**PROJECT NO. ST87600114-3
GRAND CANAL BIKE AND PEDESTRIAN IMPROVEMENTS
FEDERAL AID NO. PHX-0(BFG)F**

ADDENDUM NO. 5

ISSUE DATE: September 20, 2017

THOMAS ROAD & CANAL HAWK SIGNAL

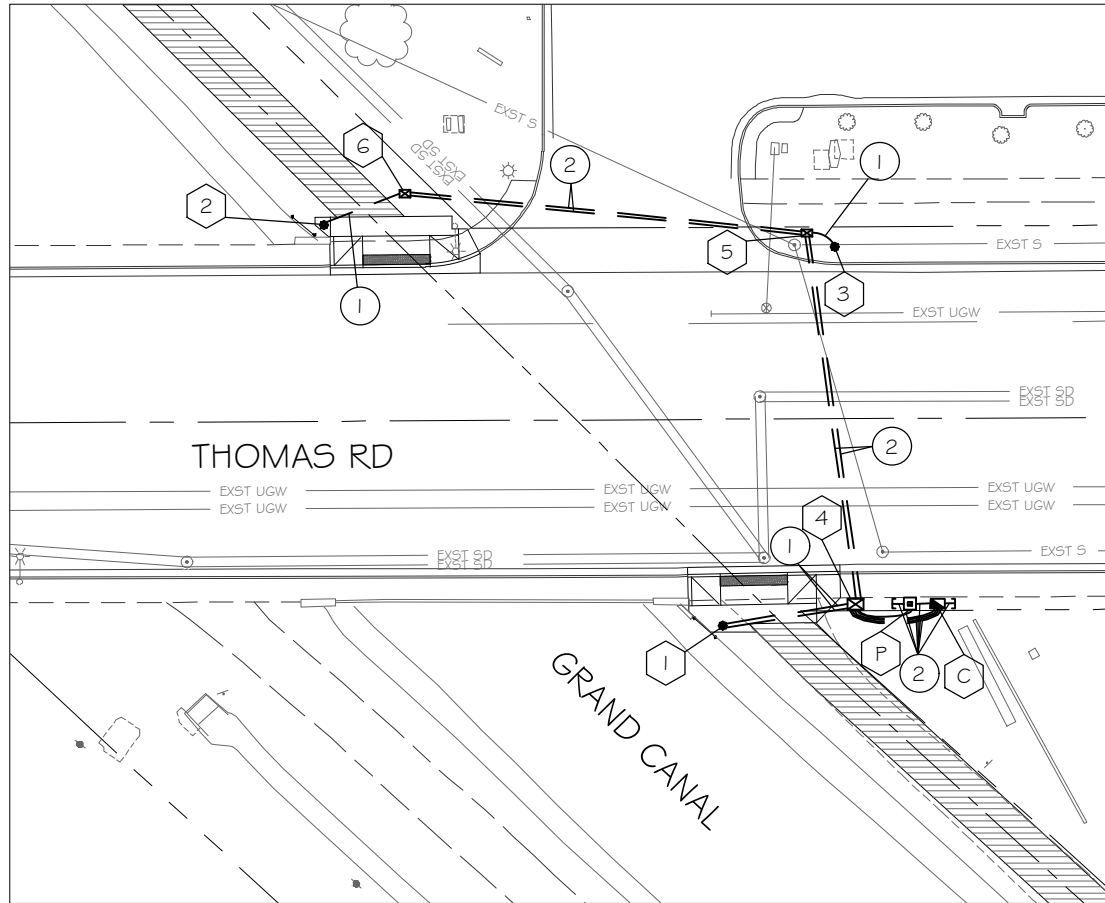
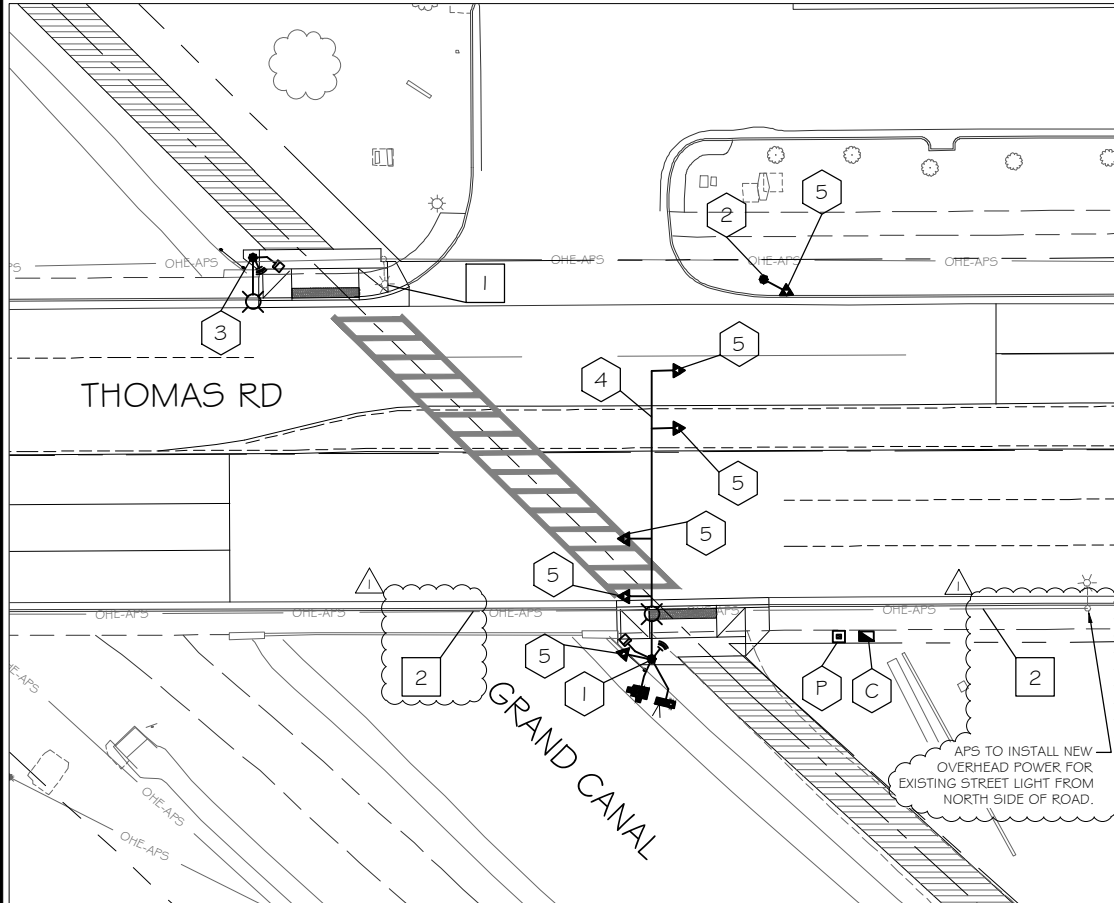
A6.	Conduit sizes have been added to plans.
Q7.	Item 6.14 – Plan sheet 2.156 shows luminaires on the G & W signal poles in the layout but under the equipment notes there does not appear to be a callout. Please confirm these are required.
A7.	Both poles shall have LED luminaires. See updated equipment notes.
Q8.	PDF Page 39, Special Conditions 22, Section 2- at Union Pacific Railroad Flagman, at Measurement and Payment, second paragraph – The paragraph says "Payment for this work will be made under the bid item Railroad Flagman and Right of Entry Permit." There is no such bid item in the Bid Proposal. Please clarify.
A8.	A new bid item is added for this purpose. See revised bid tab attached.
Q9.	PDF Page 141, DBE Program, Section IV.A.1., Attachment A (Outreach Efforts) – The section mentions documentation due at the time of bid which is not included in the list on PDF Page 8, Information for Bidders, Section H, Bid Submittal Checklist. The section describes an "Attachment A (Outreach Efforts)." a) Is Attachment A required with the bid? b) If yes, please provide Attachment A

1. **Sheet TS-2.156 (Thomas Road & Canal HAWK Signal):** Replace this sheet with the revised Sheet TS 2.156.
2. **Sheet TS-2.160 (Oak Street & Canal RRFB):** Replace this sheet with the revised Sheet TS 2.160.
3. **Sheet TS-2.164 (32nd Street & Canal HAWK Signal):** Replace this sheet with the revised Sheet TS 2.164.

F.H.W.A. REGION	STATE	PROJ. NO.	NO.	TOTAL
9	ARIZ.	ST87600114	2.169	2.182
 ENGINEERING & ENVIRONMENTAL CONSULTANTS CONSULTING ENGINEER				
DES: DVG	DR: DVG	CK: CMT	DATE: 07/14/17

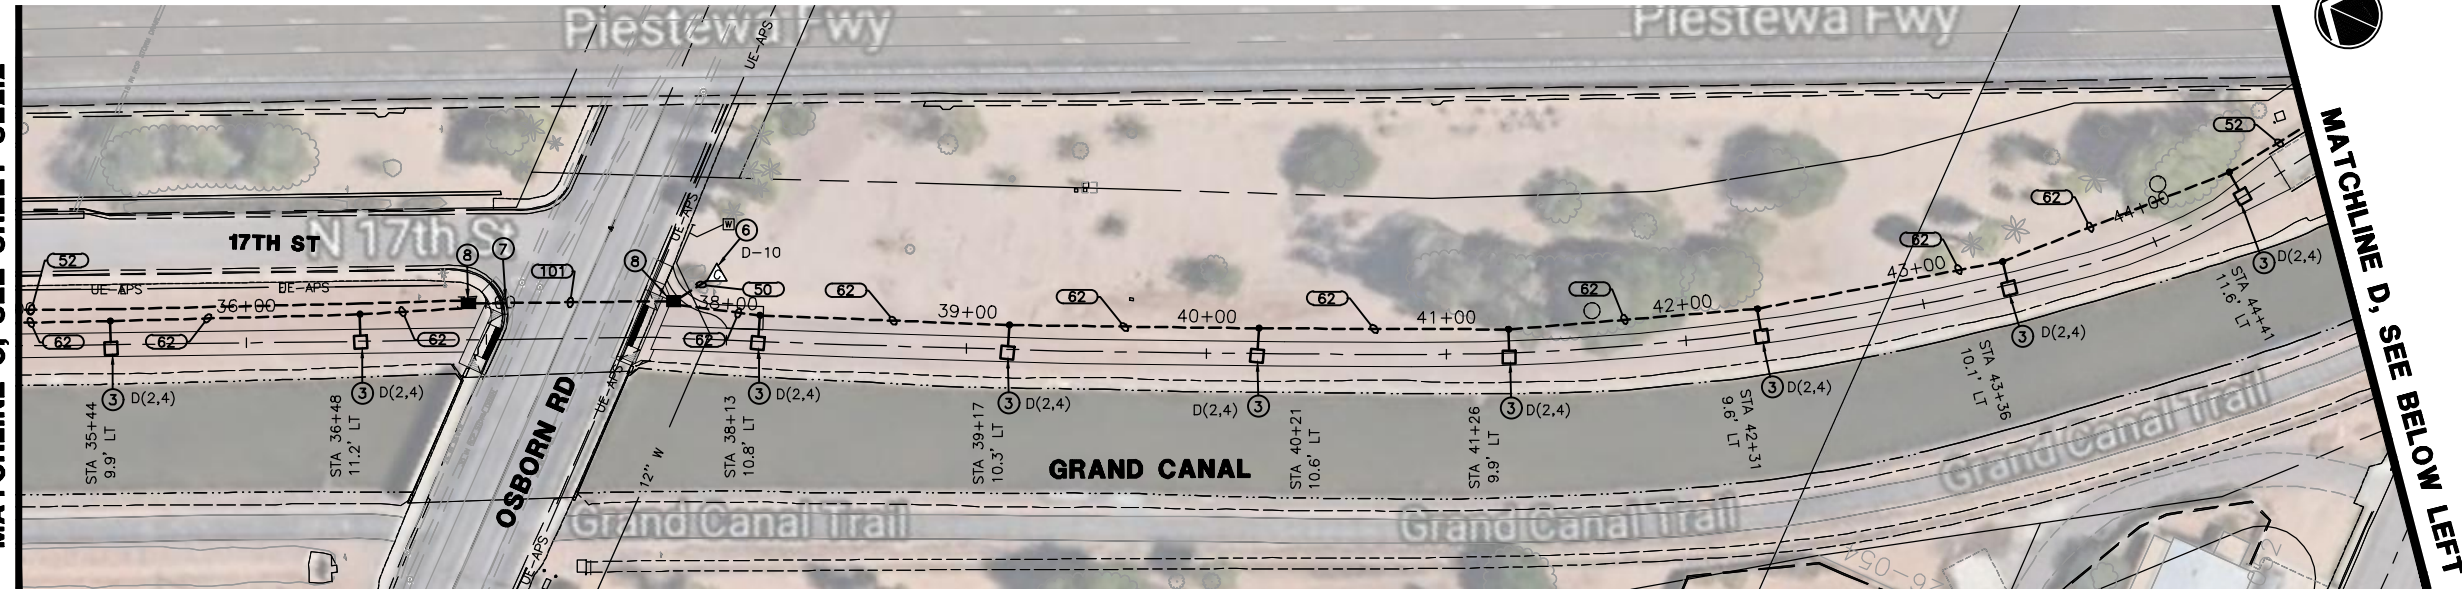
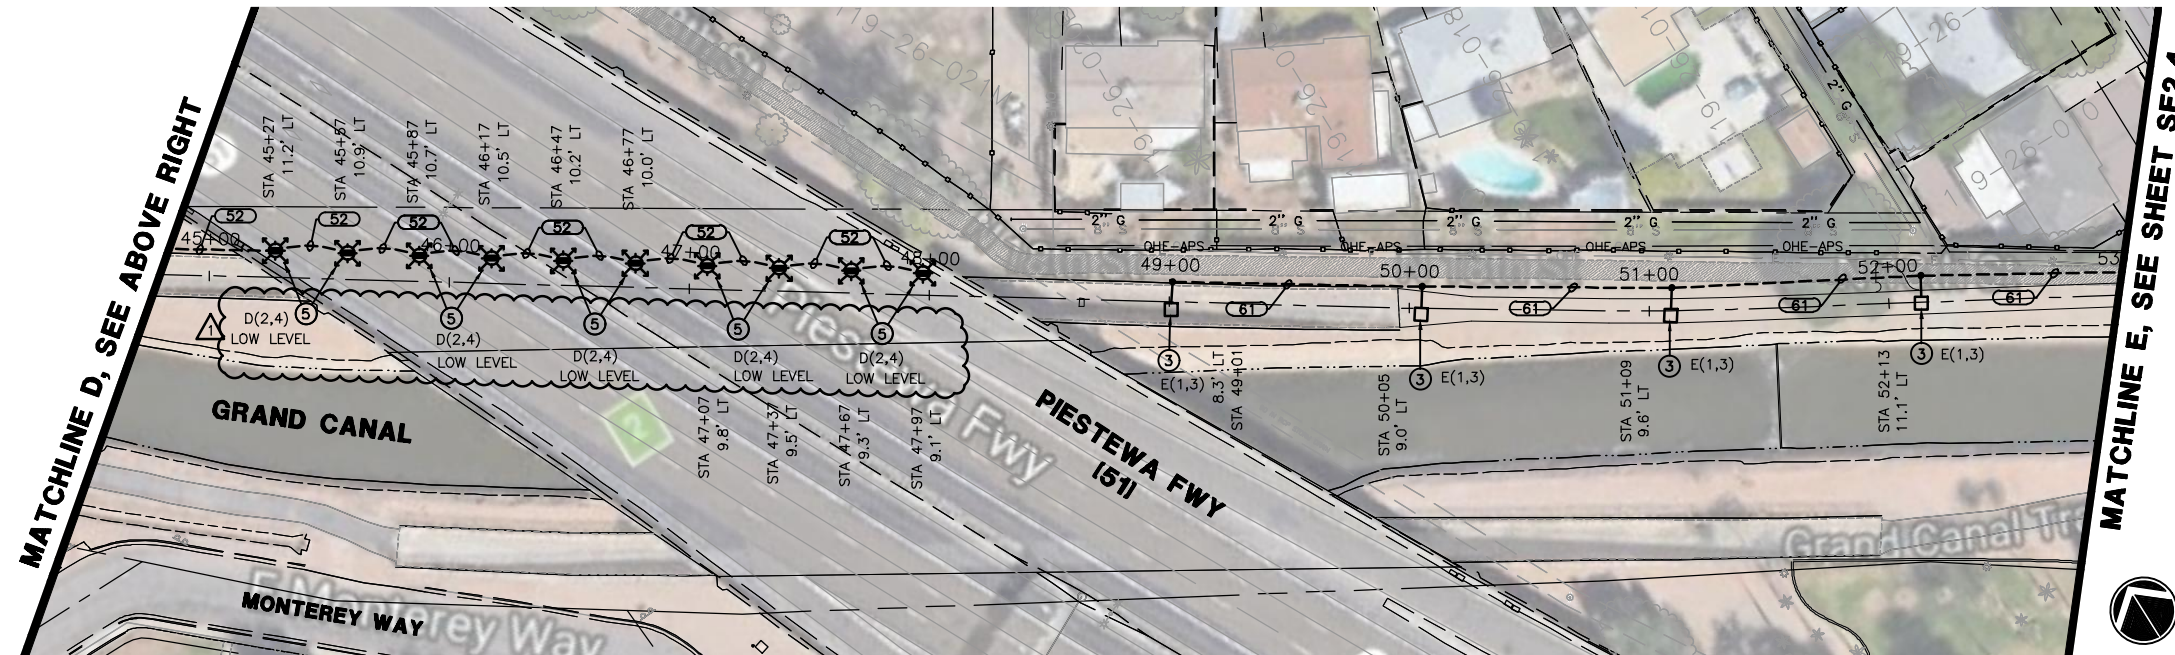
6. **Sheet TS-3.87 (RRFB – 48th St Foundation):** Replace this sheet with the revised Sheet TS 3.87.
7. **Sheet 2.169 (SE2.3):** Replace this sheet with the revised Sheet 2.169.

TYPICAL SECTION NO. 1

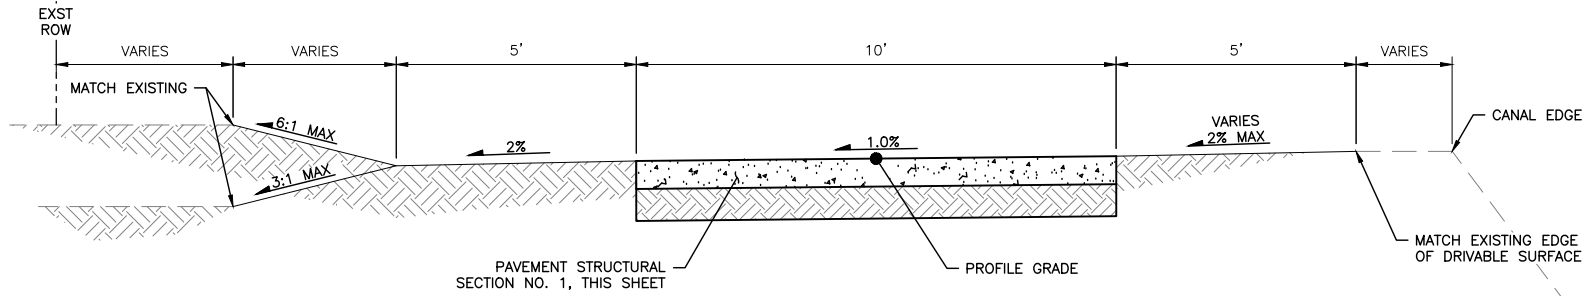
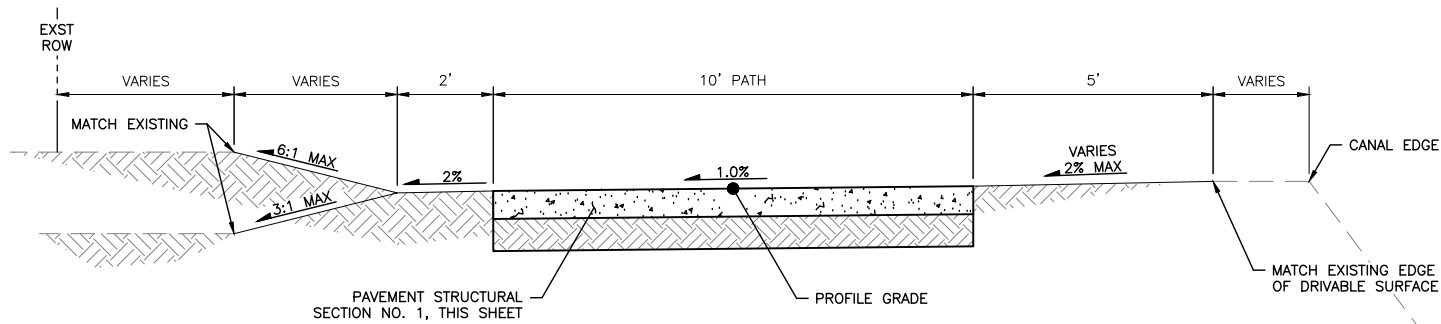
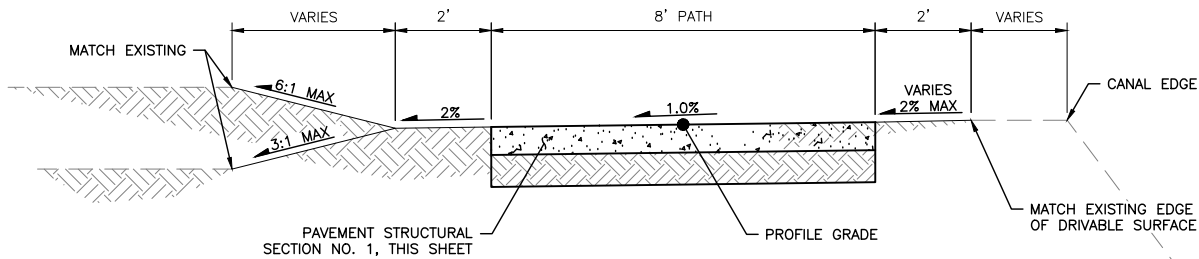
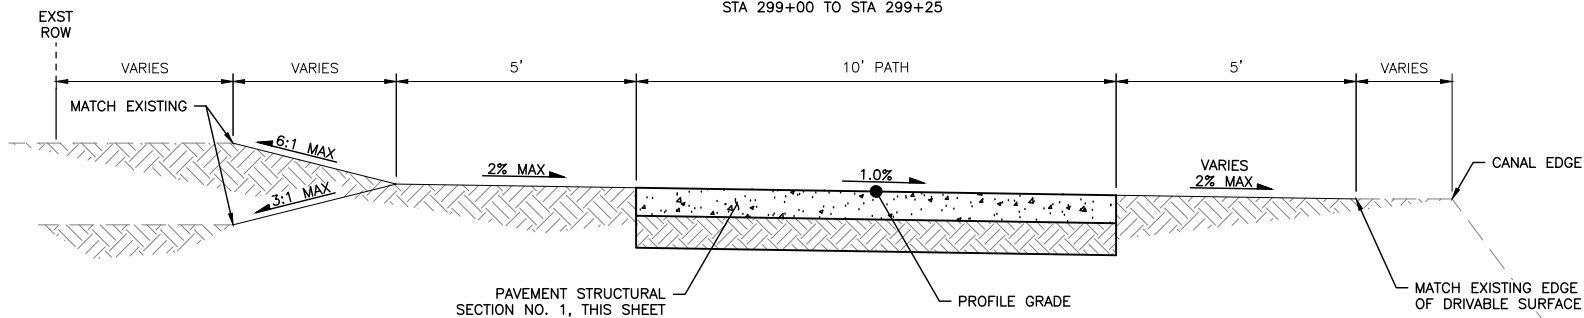
A9.	Please see Addendum 4.
Q10.	Item 6.18 – Plan sheet 2.164 shows an "SQ" foundation on the proposed foundation schedule however on the Hawk Equipment Notes the plans are calling for an ADOT Type W Pole. What is the correct pole for this location?
A10.	The correct pole and foundation is an ADOT type W pole. See updated foundation schedule.
Q11.	Plan sheet 2.169 shows conflicting information. Please confirm bollards or light fixtures on 15' poles.
A11.	Those are bollard lights and should have been note 5. See revised sheet SE2.3.
Q12.	Volume 2 Page 2.003 shows a table of bid items and quantities. Item # M3400407 calls for Concrete Sidewalk with WWF (welded wire fabric). Similar bid items for the path for example ex. Volume 1 page 1.04 calls for Concrete Sidewalk Std Detail 1230 7" thk

Class AA. The pavement section drawings call out PCCP, not sidewalk. Is this path PCCP or sidewalk? Is WWF required.
A12.	Pathway shall be Concrete Sidewalk Std Detail 1230 7" thick Class AA. See revised Sheets 3.05
Q13.	Will the joints for the path be tooled (Sidewalk) or can they be sawcut (PCCP)?
A13.	Construction of joints shall be per Std Detail P1230.
Q14.	The material is called out as weathering for the structure, mesh, and bar grating. However later in the specifications, it mentions "colorant for galvanized metal" and mentions Natina Stain. What is the finish for the bridge? If galvanized and stained, are we still required to use A588 material instead of the standard A500?
A14.	See page S.P. – 70 of the special provisions for the material requirements of the Prefabricated Steel Bridge. The material requirements listed on page S.P. – 71 and 72 are applicable to the Steel Handrail details located on Sheet 2.127.

8. **Sheet 2.003 (Quantity Summary):** Replace this sheet with the revised Sheet 2.003.
9. **Sheet 3.05 (Typical Sections):** Replace this sheet with the revised Sheet 3.05.
